H114 UPS4118-1bNAS1

TECHNICAL BULLETIN

418-02: Wiring Harnesses

Update Prior to Sale: Unsealed Splices on Rear Axle and Cabin Harness

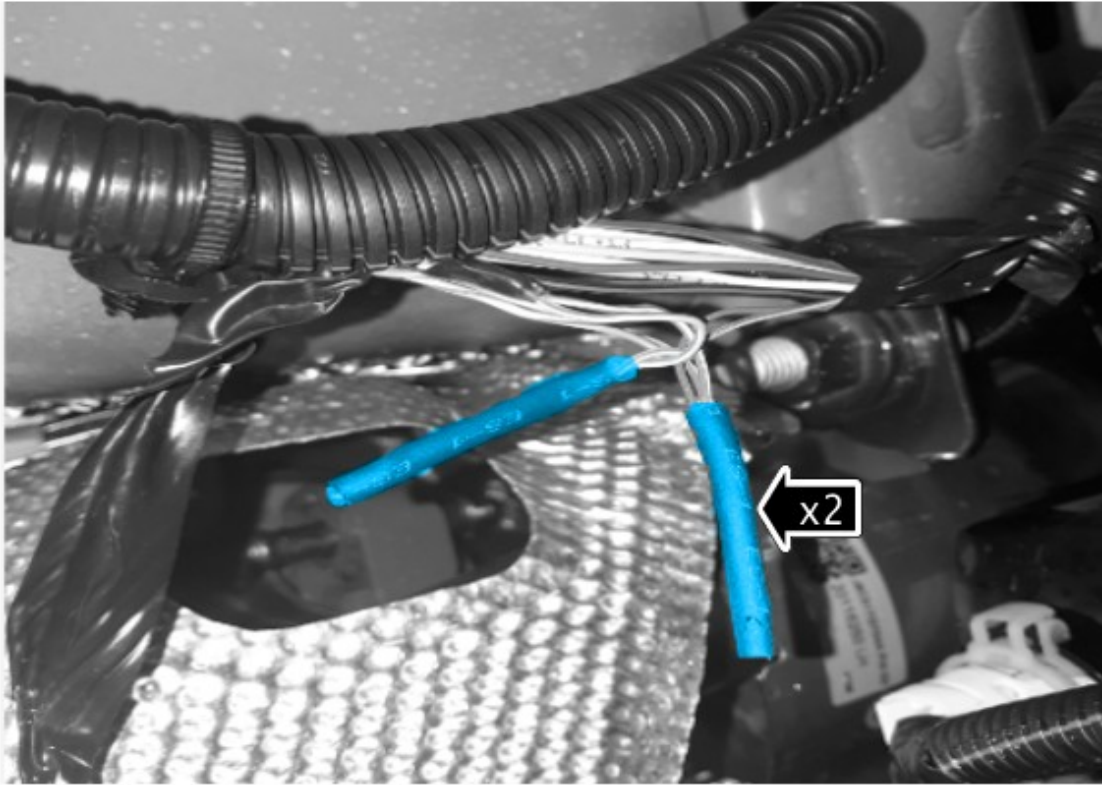
- 3 Locate splices **S3DB27G** and **S3DB28G** using (see TOPIx section Electrical Information - Electrical Wiring Diagrams - 413-09: Warning Devices - Blind spot monitoring system).

E227017

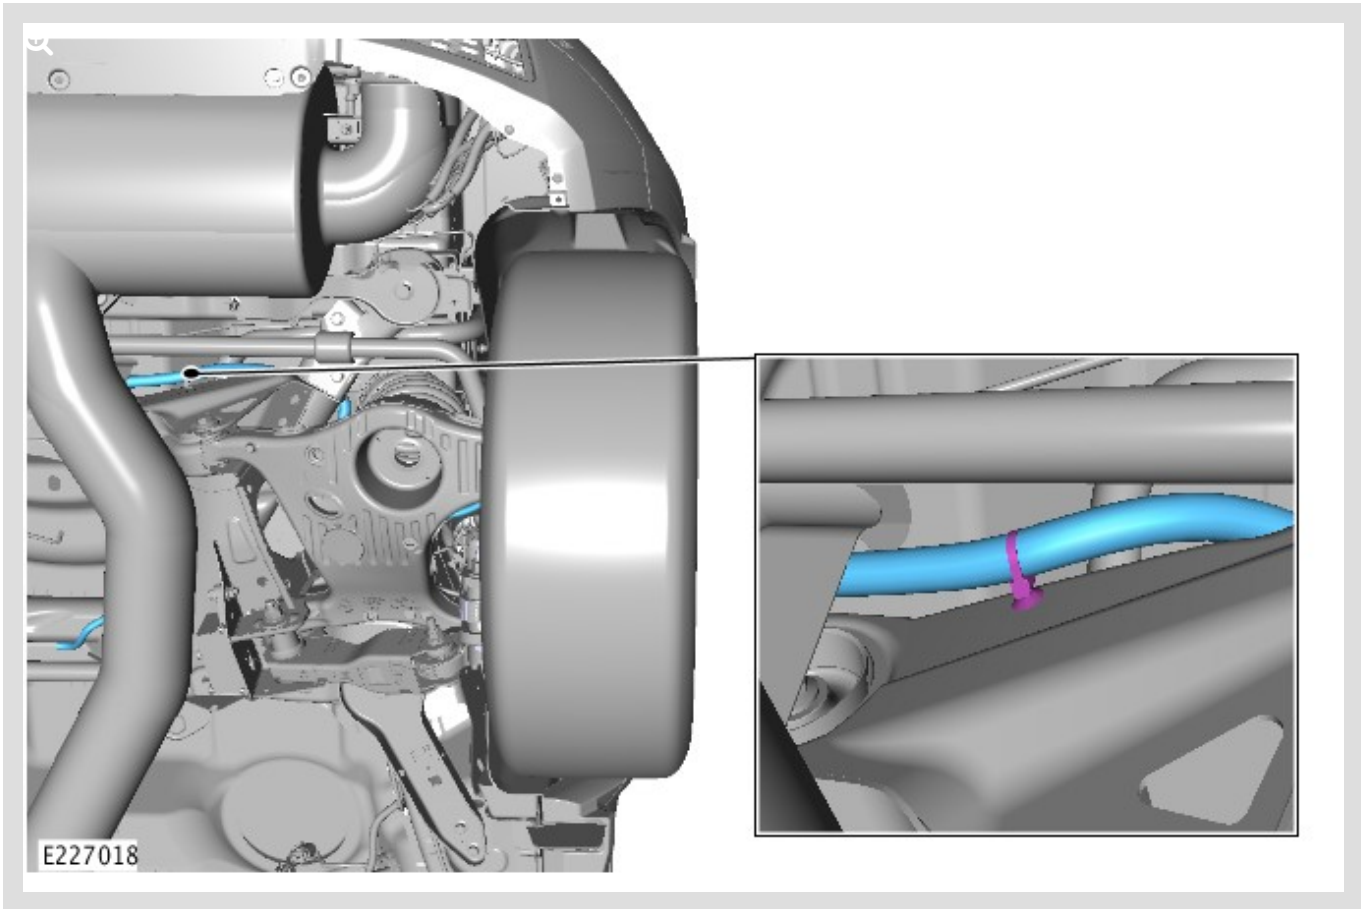
Apply heat shrink to splices **S3DB27G** and **S3DB28G**

- 1 Apply electrical tape.
- 2 Install the body wiring harness protection.

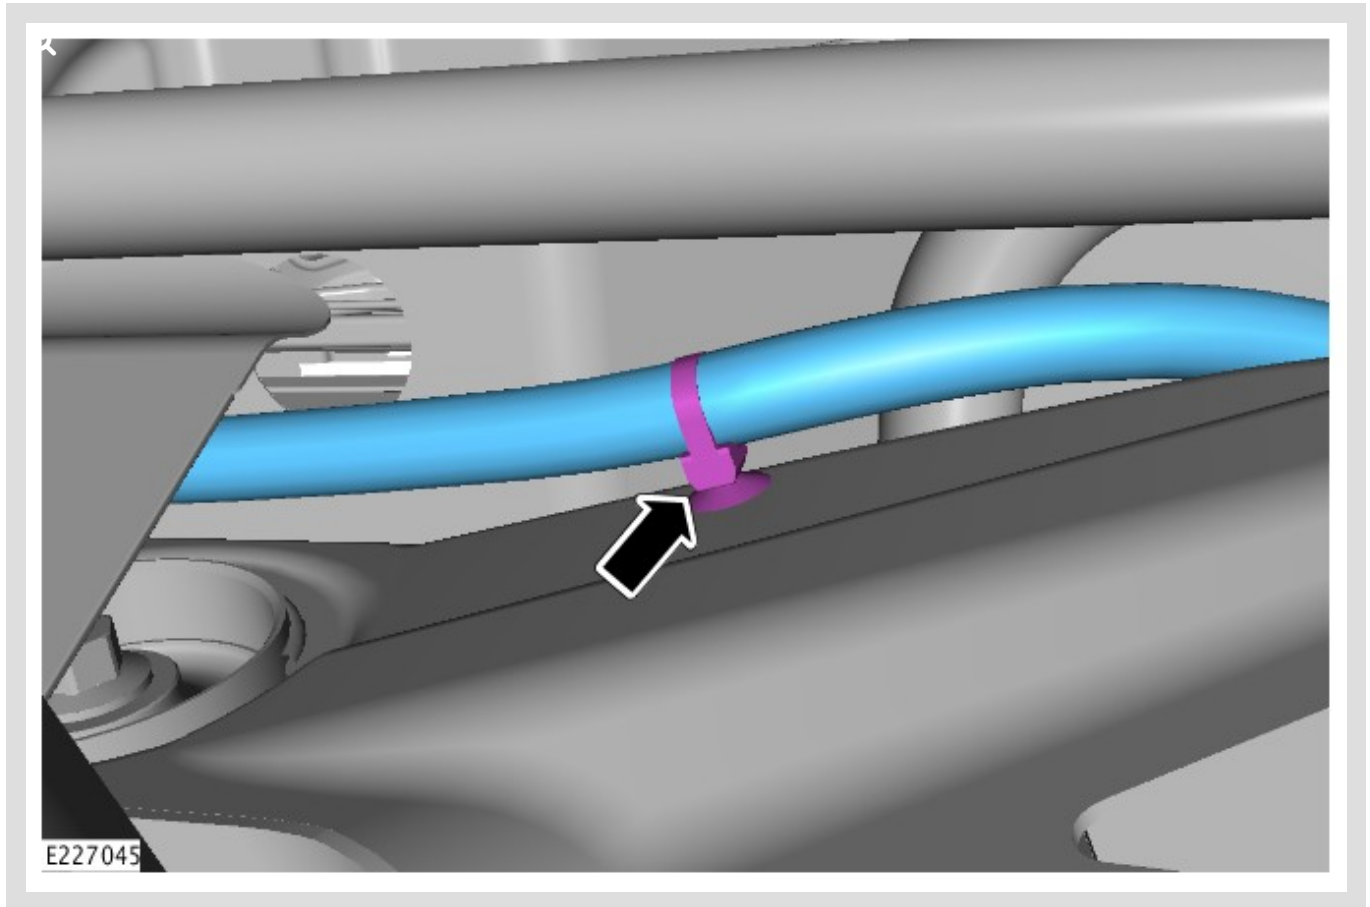
8 Locate splices **S4DB26GD**, **S4DB25GD**, **S4DB26GE**, and **S4DB25GE** (see TOPIx section Electrical Information - Electrical Wiring Diagrams - 205-02: Rear Drive Axle and Differential:).

Apply heat shrink to splices as shown:

- 1 S4DB26GD and S4DB25GD**
- 2 S4DB26GE and S4DB25GE**
- 3** Apply electrical tape.
- 4** Install the body wiring harness protection.
